# Town of Groveland Americans With Disabilities Act (ADA) 2020 Accessibility Project

June 2020

# Americans With Disabilities Act (ADA) Consulting Self-Evaluation and Transition Plan Town of Groveland

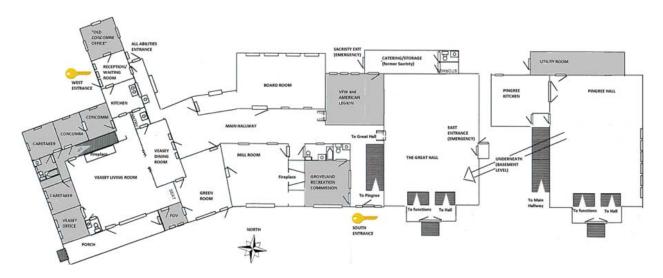
The Great Hall provides a large performance stage. We recommend 7-8 ft. ramp cut into the stage area with railing installed. This ramp would require a 3 feet wide section of the stage be cut into for seven feet to provide a perfect, gentle slope ramp. This will enable better access to the stage, as well as the VFW meeting room.
